L-2008-161
10 CFR 50.90

RE: St. Lucie Units 1 and 2
Docket Nos. 50-335 and 50-389
Proposed License Amendment
Request for Additional Information Response
Alternative Source Term Amendment – TAC Nos. MD6173 and MD6202

**Units 1 Control Room Outside Air Intake (CROAI)
Radiation Monitoring System
Design and Proposed Modifications**

CONTROL ROOM OUTSIDE AIR INTAKE MONITORS

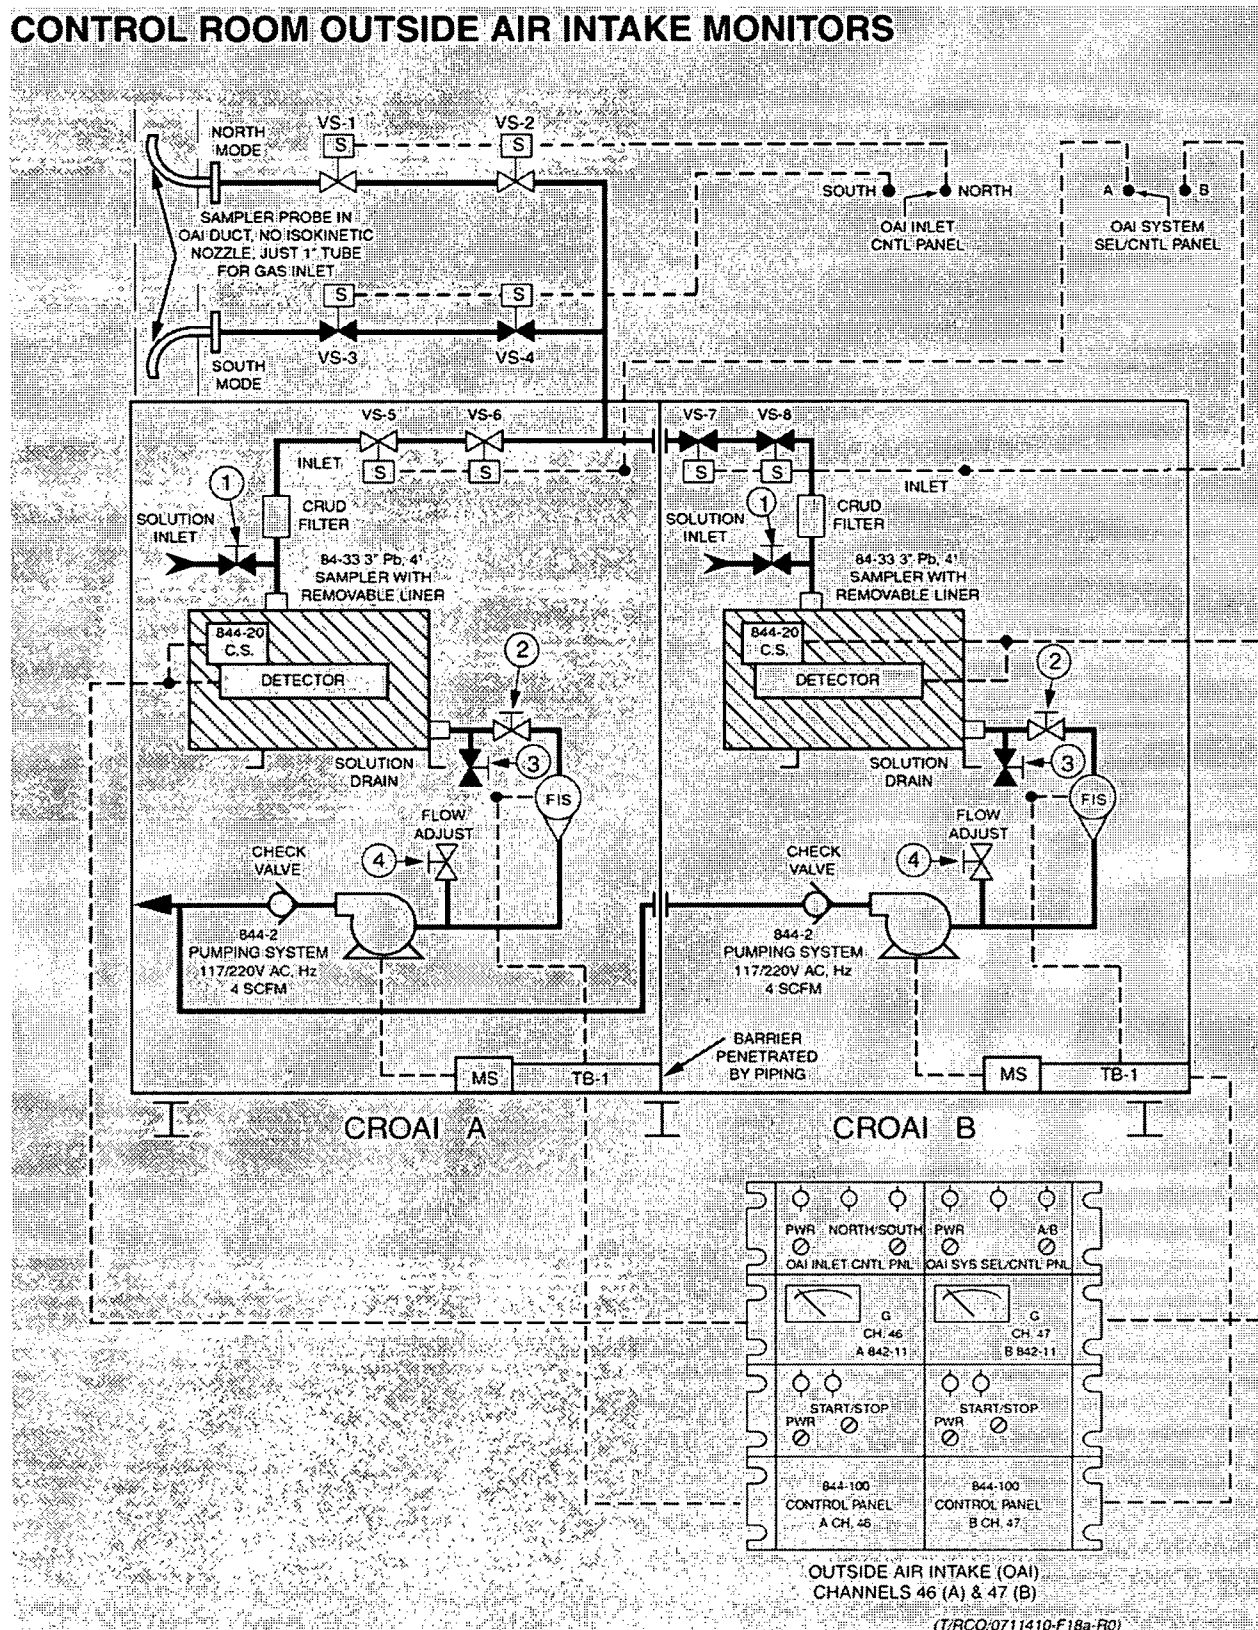
The Control Room controls consist of an OAI Inlet Panel, OAI System Select Control Panel, 'A' OAI Pump Control Panel, 'A' Outside Air Intake Log Ratemeter, 'B' OAI Pump Control Panel, and 'B' Outside Air Intake Log Ratemeter. Refer to Figure.

These panels are used to select the operating mode of this system. For example, the operator can choose to use the 'A' OAI Radiation Monitor (which requires the 'A' OAI Sample Pump) or the 'B' OAI Radiation Monitor (which requires the 'B' OAI Sample Pump). Either sample train can be selected. In addition, the operator can select to sample air from the north OAI or the south OAI. Refer to Figure.

CONTROL ROOM OUTSIDE AIR INTAKE (CROAI) MONITORS (Post Modification)

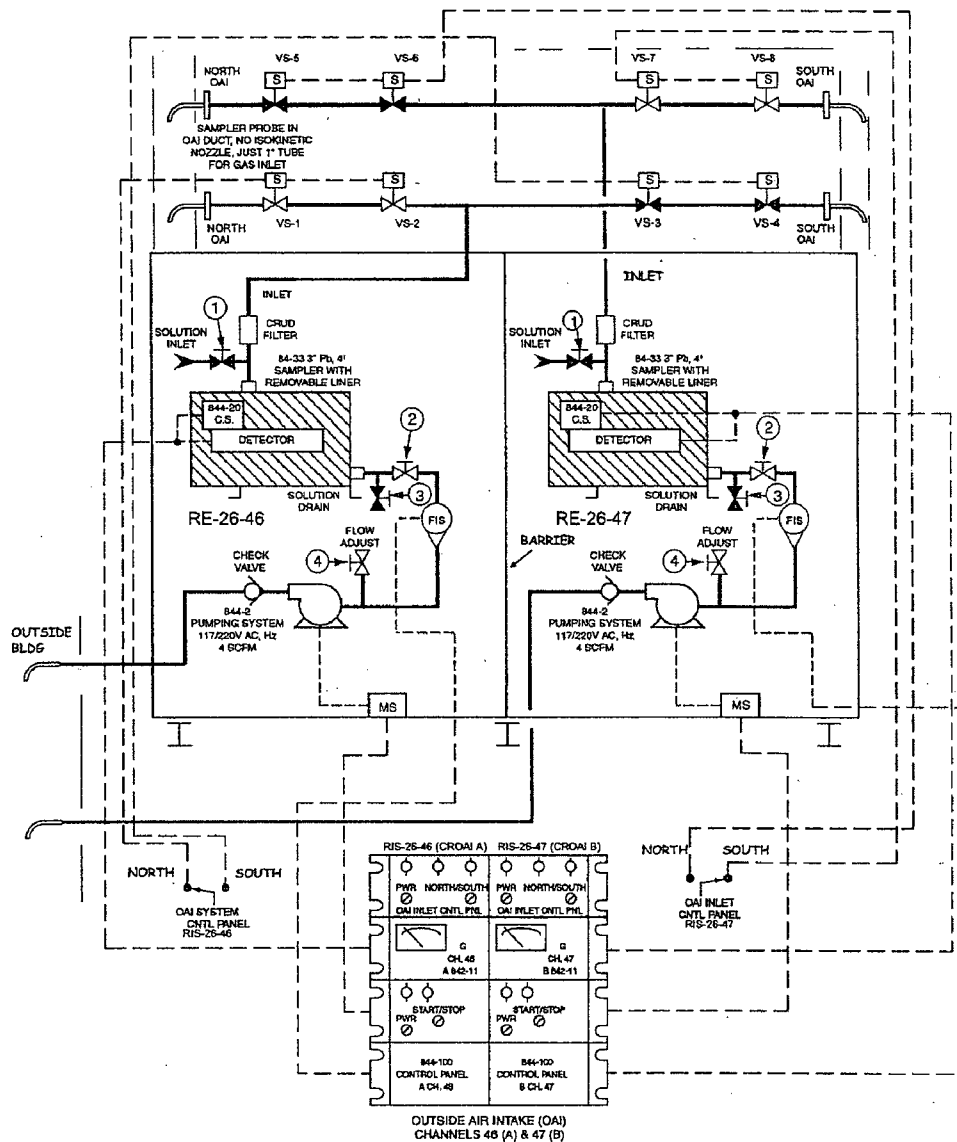
- a) "High Radiation" detected by either CROAI radiation monitor will actuate both trains of control room ventilation system isolation/recirculation. Currently, the CROAI radiation monitor in service will only actuate its associated control room ventilation system train (i.e. RIS-26-46 actuates the A train ventilation components and RIS-26-47 actuates the B train ventilation components).

- b) Additional tubing will be provided to enable both sample pumps to be operated simultaneously and exhausted to the outside atmosphere. This allows both CROAI radiation monitors to be operated simultaneously. Currently, only one of the two CROAI radiation monitors can be operated at any time.

- c) The sample pumps will be reconfigured to be powered from a respective A train and B train emergency diesel generator (EDG) backed source. Currently, the sample pumps are powered from an AB train source.

- d) CROAI radiation monitor electronics will be powered from the same power source as its associated sample pump. Currently, the CROAI radiation monitor electronics are

- powered from non-essential power panels that require manual action to connect them to their associated EDG.
- e) The sample isolation valves will be reconfigured to be powered from a respective A train and B train DC source. Currently, the sample valves are powered from a B train DC source only.

- f) A reactor turbine generator board (RTGB) annunciator window will be added for “CROAI Monitor Failure” and “Low Sample Flow.” Currently, a common control room alarm exists for all radiation monitors in the plant. The flow fault circuit will be modified to provide control room annunciation. Currently, sample flow is provided by the single sample pump in service. Sample flow failure currently provides local indication via an amber flow fault light on the respective pump control panel.

- g) Two channel bypass switches will be installed to facilitate radiation monitor surveillance testing without initiating control room isolation. The channel bypass switches will cause an alarm on the RTGB annunciator window when a channel is placed in bypass.

Attachment 3 provides a simplified diagram of the Unit 1 CROAI radiation monitoring system after these proposed modifications are implemented.
